TO: Mercedes-Benz Dealer Principals, General Managers, Sales Managers, Service Managers, Parts Managers	FROM: Gregory Gunther, Department Manager, Vehicle Compliance and Analysis, Engineering Services
RE: Recall Campaign Launch Notification Check Sliding Roof Bonding MY01-11 C-Class, CLK-Class, E-Class and CLS-Class (203, 209, 211 and 219 platform)	DATE: January 20, 2023

Recall Campaign Bulletin

Campaign No. 2023010005, January 2023

Check Sliding Roof Bonding

Figure 3

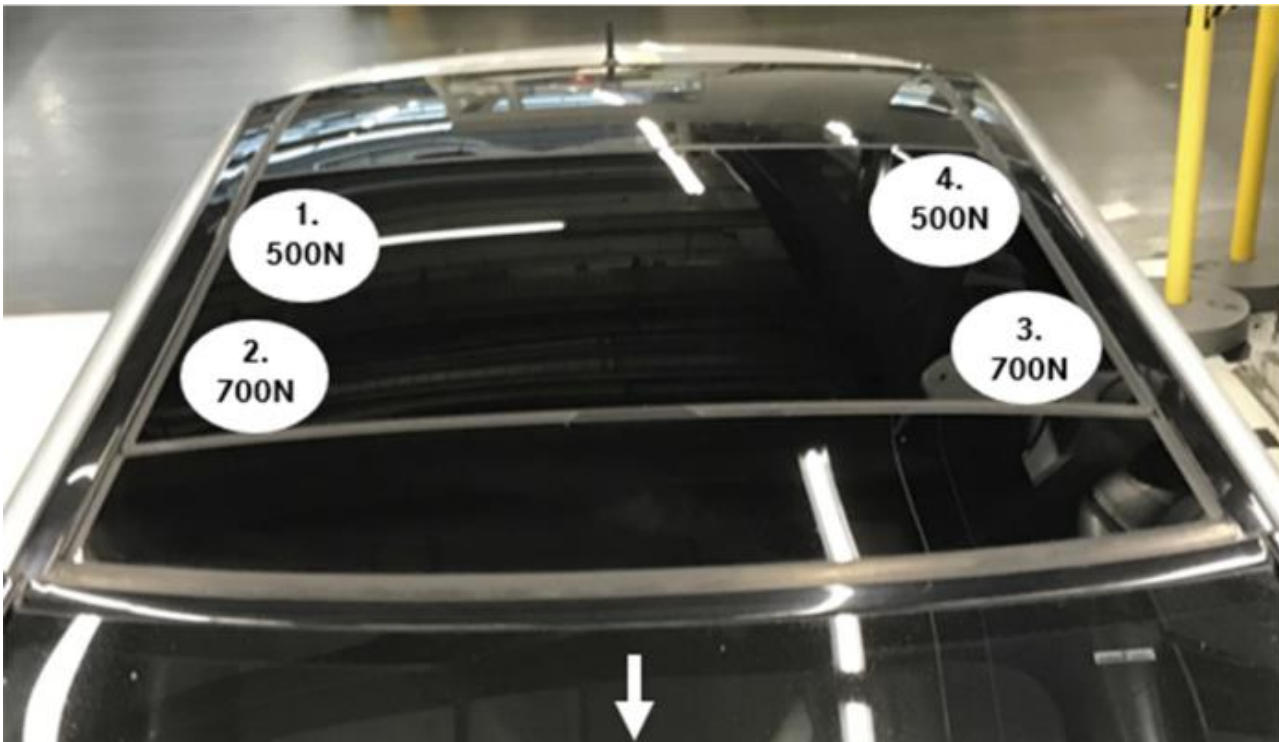
i The suction cup tool may be used for this check.
 3. Position suction cup tool (Figure 3) and pull as **vertically** as possible (tolerance of ± 10 degrees) using lifting tool.

i Position suction cup tool at 4 positions in the sequence **1, 2, 3, 4:** (Figure 4).

i The specified force must be monitored during the first minute and adjusted if necessary (tolerance ± 10 N). The specified force must not be exceeded. Pull as vertically as possible (tolerance ± 10 degrees) with the specified force. Not person sh be inside the vehicle during the check, and the vehicle must not be touched if possible.

Figure 5, not OK (shown on an SHD)

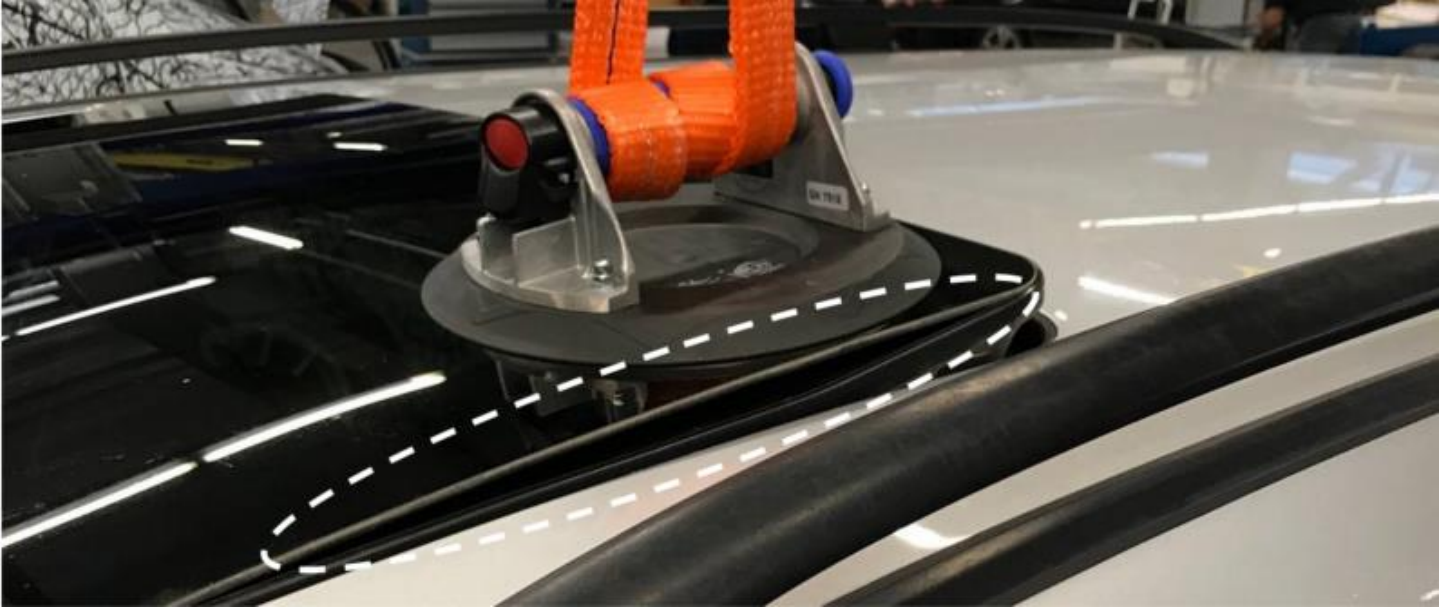
i If the panoramic sliding sunroof panel detaches from the padding of the tilting/sliding sunroof frame at one of the test positions (see Figure 5), the glass cover must be replaced.

- c. If the panoramic sliding roof panel detaches from the padding: Carry out **work procedure**.
- d. If the panoramic sliding roof panel **does not** detach from the padding: Carry out operation step 4 and **end measure**.

1. Replace panoramic sliding sunroof cover (AR77.21-P-0500PB).
-
